ONSITE SEWAGE DISPOSAL SYSTEM

ONSITE SEWAGE DISPOSAL SYSTEM DESIGN PLAN

MEMORANDUM

RE: OSDS Plan
Hudson Property, Holly Hills, Section 2
Map: 41, Parcel: 92, Lot 18

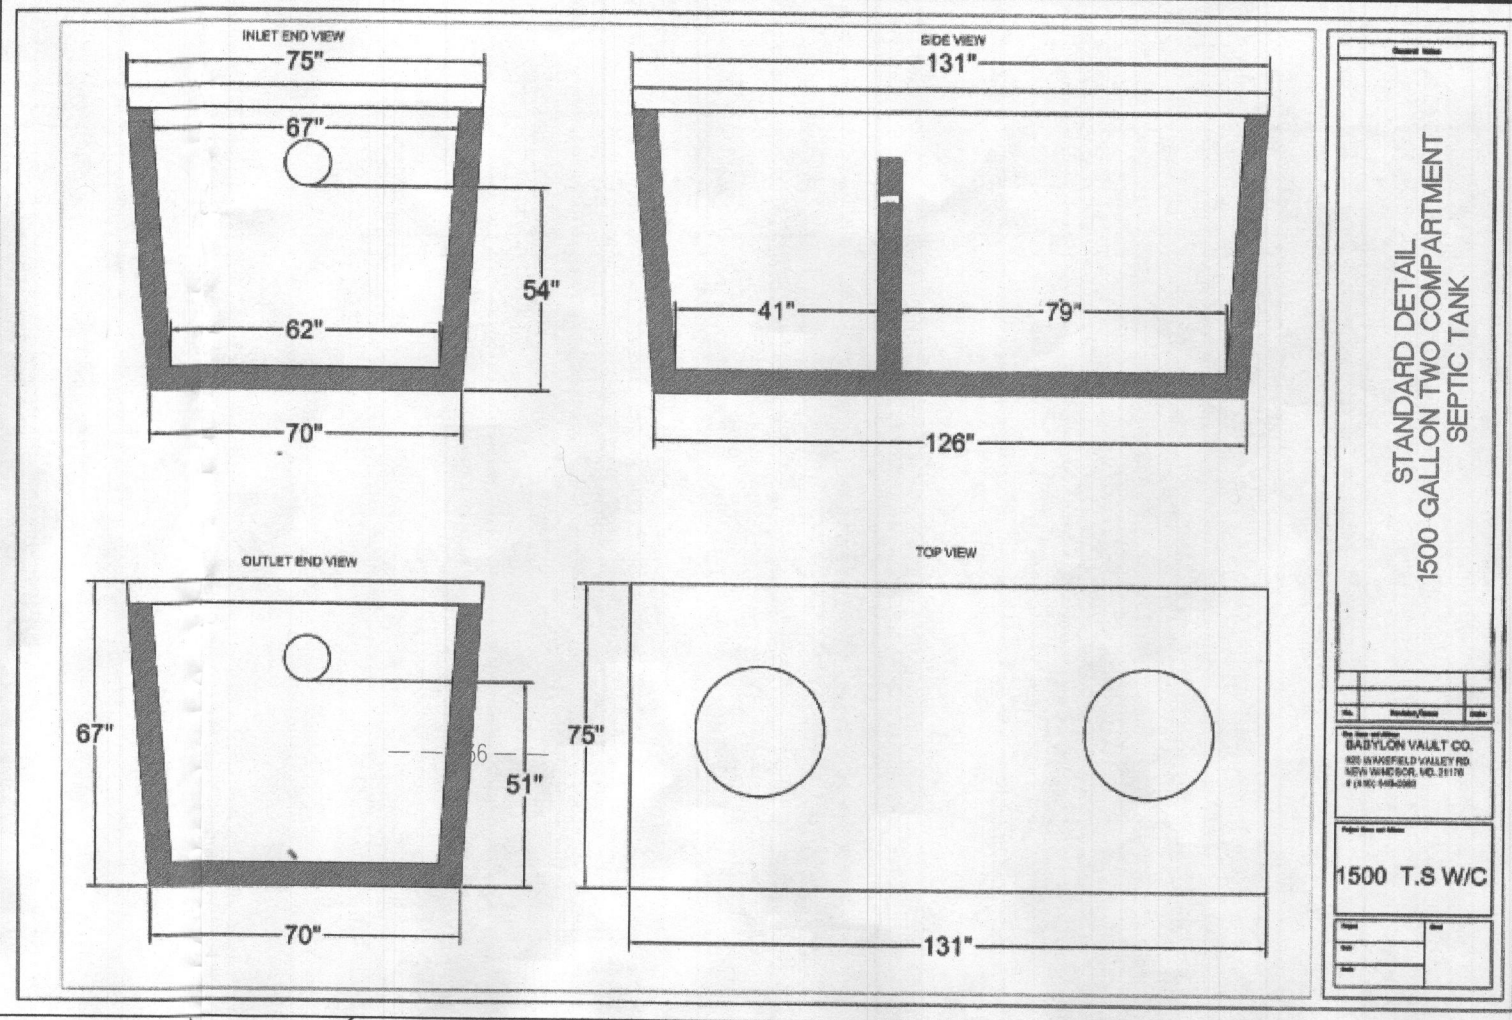
10/23/18 Tank location staked, may want to turn tank slightly
 Contractor informed. SDA corner staked. Could not do layout, large amount
 of fill/spill piles need to be removed. OK to set tank
 while. (K) 11/29/18 Met Bill with Farm + Home on site to layout trenches. Pile of dirt
 that was in SDA now gone. Laid out 5 x 75' trenches, 8' CTC. (S)

INSTALLATION: 11/19/18 House connection made + tank set. Need dirt moved out of SDA prior to
 layout of trenches. (S) 11/29/18 D-box installed. Contractor to start digging trenches. (S)
 11/30/18 T1-T3 complete. T1-T2 left open at ends for inspection + T3 left open. 2' wide, 3.5' to
 stone. (S) 12/3/18 T4-T5 complete + left open at ends for inspection. Tar seals around inlet +
 outlet pipes of D-box. Labeled speed levelers in D-box. (S)

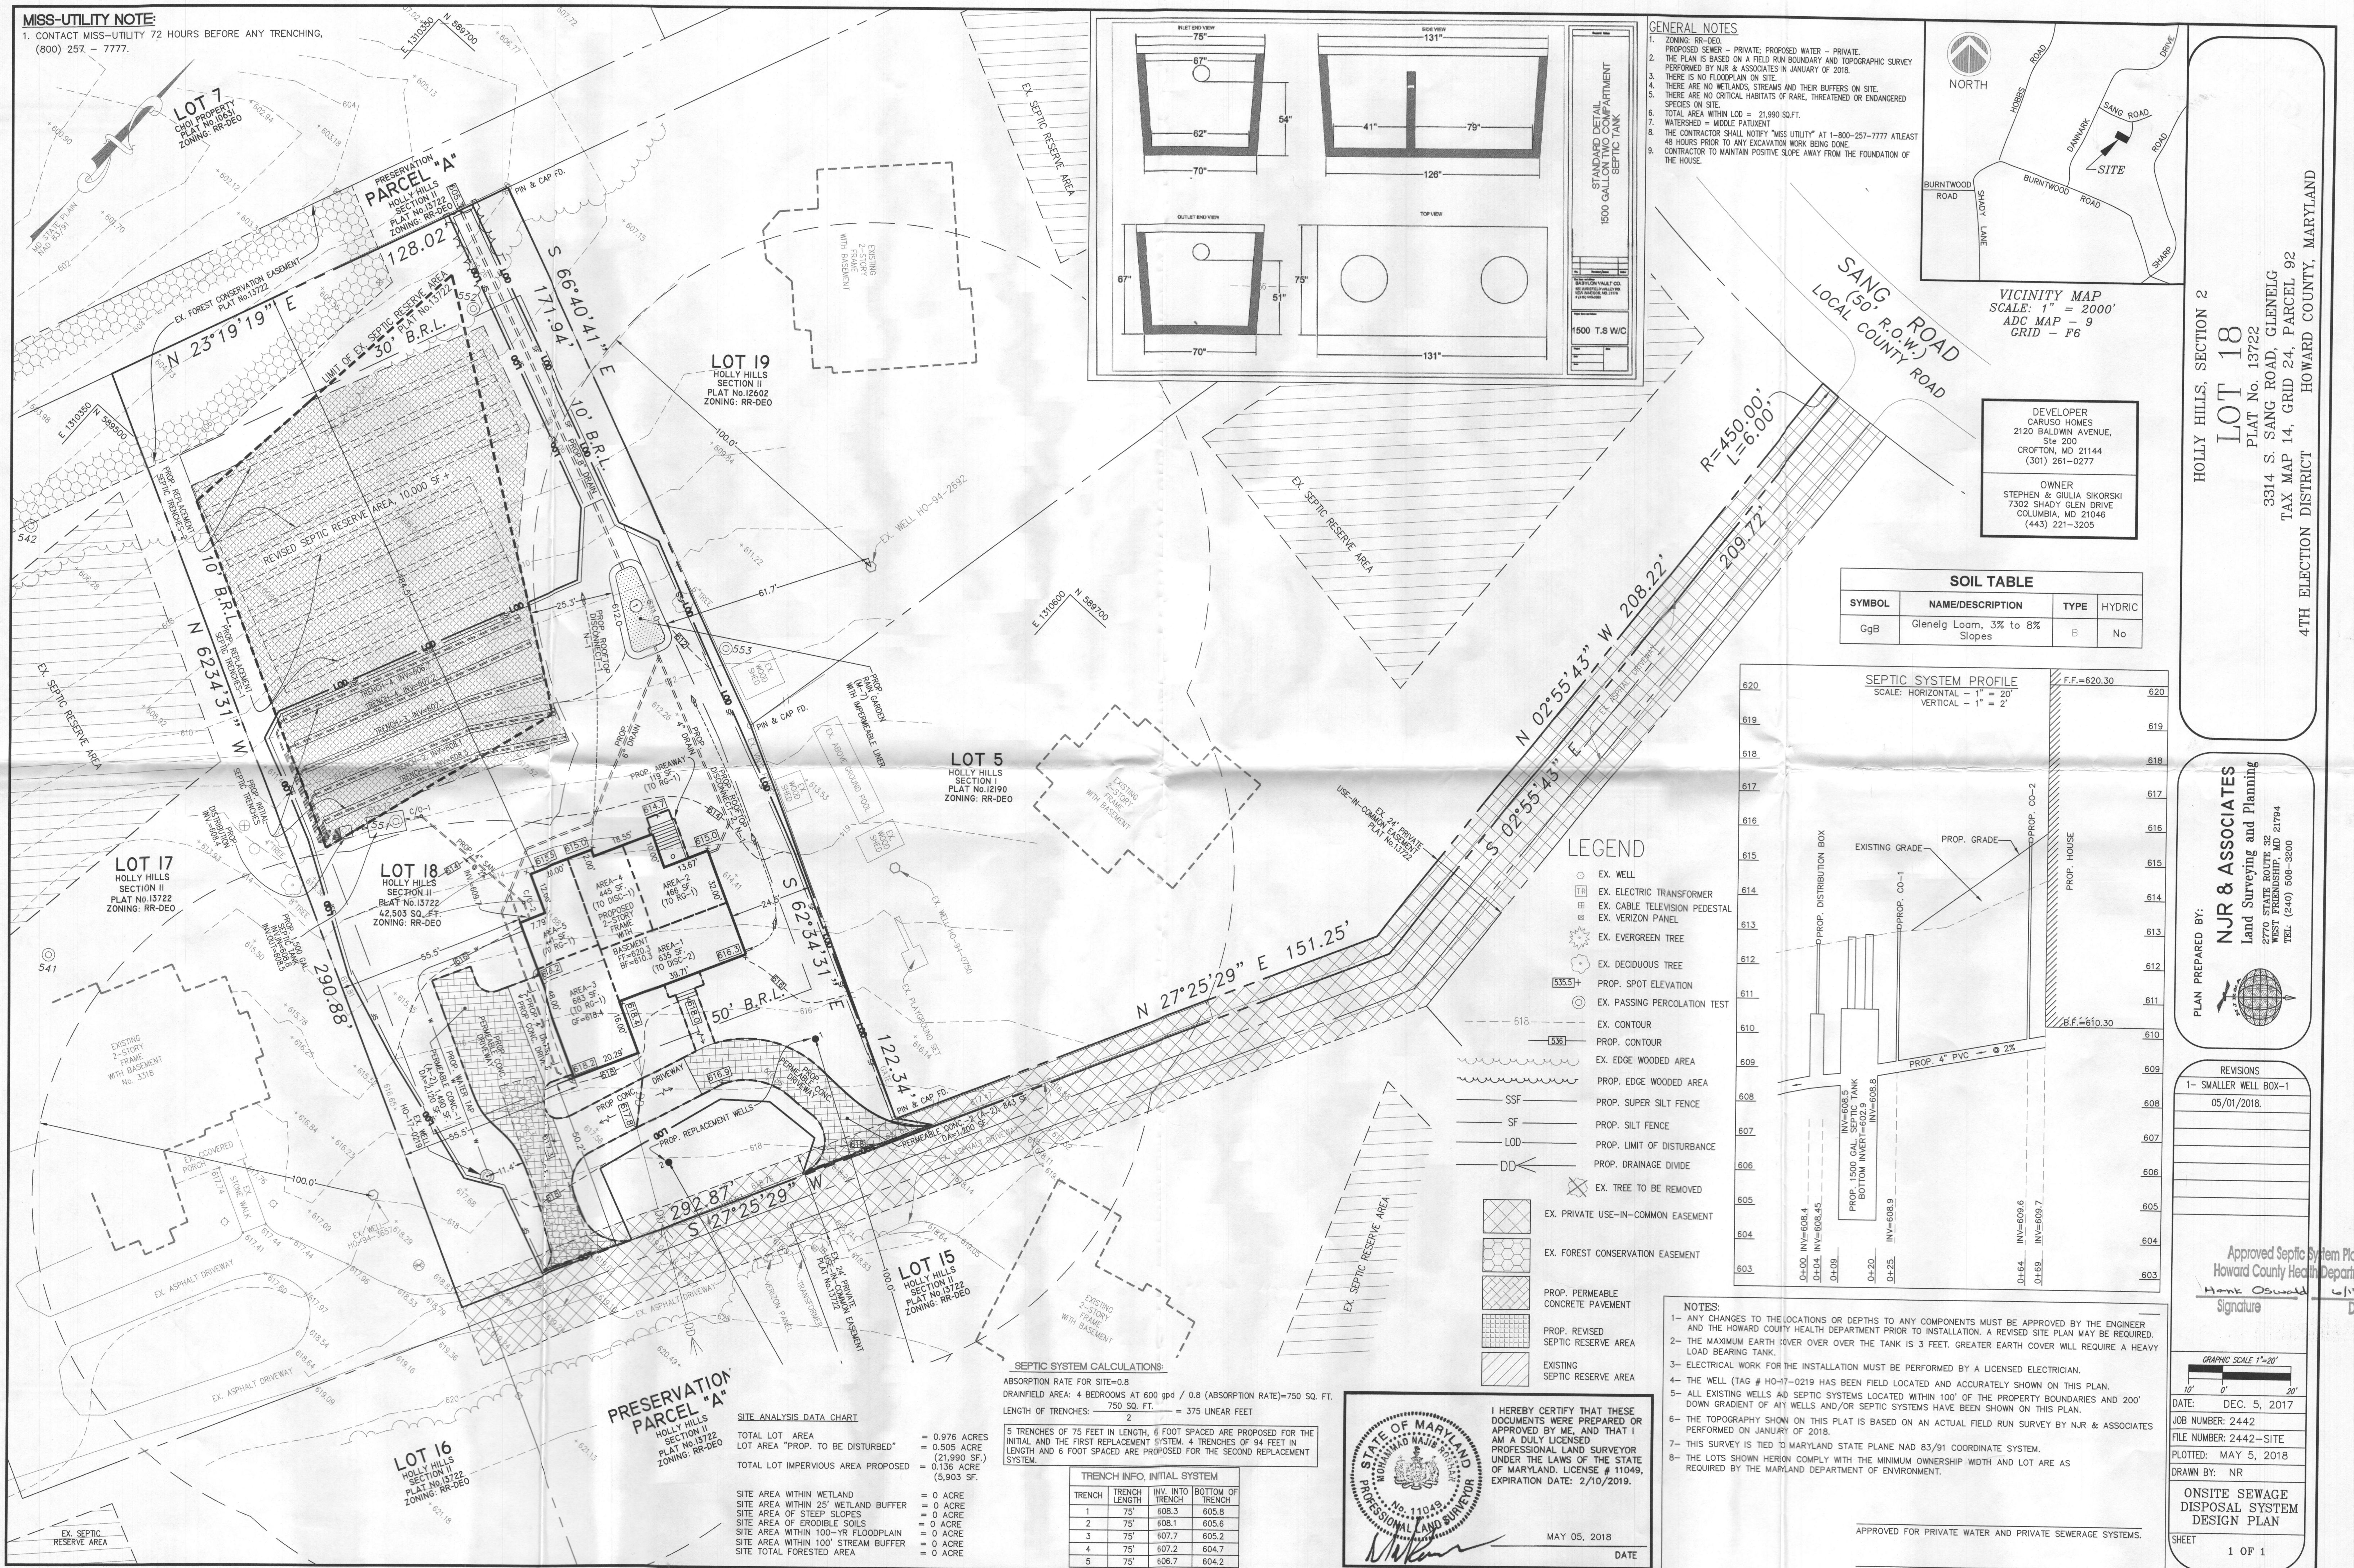
The following comments pertain to the review of the OSDS Plan for Hudson Property, Lot 18:

- ✓1.) Minimum spacing between trenches is 10 feet (edge to edge) when using sidewall credit.
- ✓2.) Show sleeve on well line under driveway.
- ✓3.) Add 2 alternate well sites meeting setbacks (i.e. 10 feet to driveway, 10 feet to lot lines, and 15 feet to road) and delete well boxes. Well box must be 1500 sq. ft. and meet all setbacks.
- 4.) Change "Shared Private Use Easements" to "Private Sewage Disposal Area" for legend symbol to match plan.
- ✓5.) Add owner information
- ✓6.) Show perc test hole locations and #s on plan.
- ✓7.) Show neighboring well radius on Lots 19 and 20
- ✓8.) You may be able expand the SDA slightly up the hill toward the well radius to squeeze in an extra trench but it will entail revising the perc cert plan.
